Product Bulletin

End of Commercialisation Notification

TeSys GV3ME80

October 2018
PB1810.1

New TeSys GV3P73 will replace GV3ME80

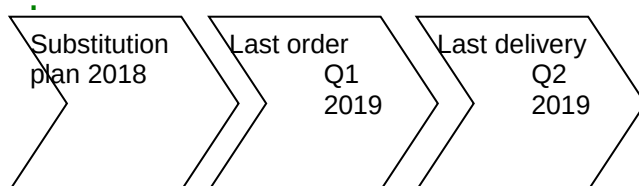
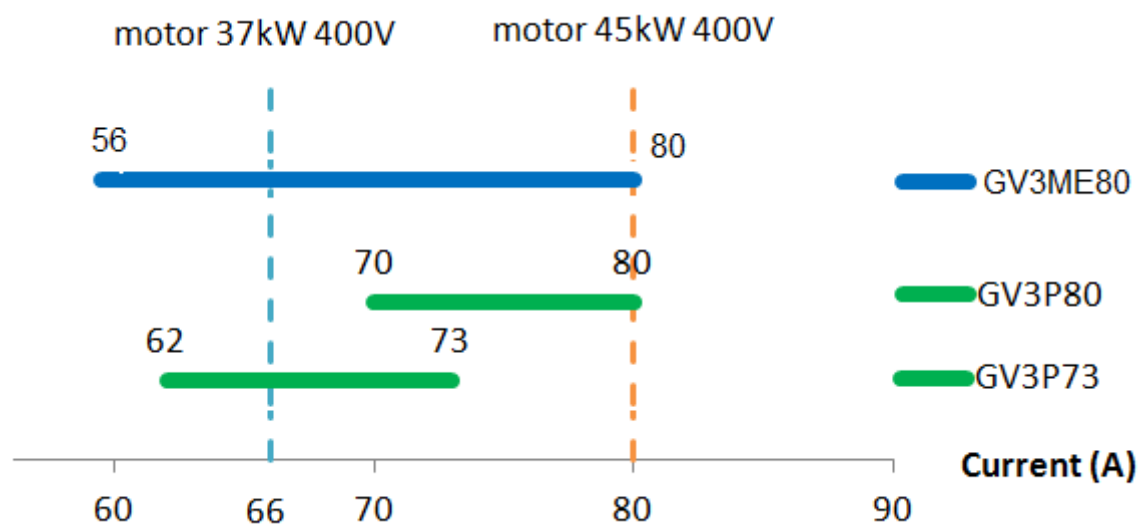
Inform our customers that for the TeSys GV3ME80 will be replaced by TeSys GV3P73

TeSys GV3P73 is new motor starter for motor of 37Kw replacing GV3ME80. GV3P73 have higher breaking capacity (50kA), rotary handle, EverLink connector and direct connection to LC1D80A contactor. GV3P73 is the main circuit breaker to replace GV3ME80 for 37kW motor, in case a full load current higher than 73A is needed then GV3P80 can be used if application is adapted.
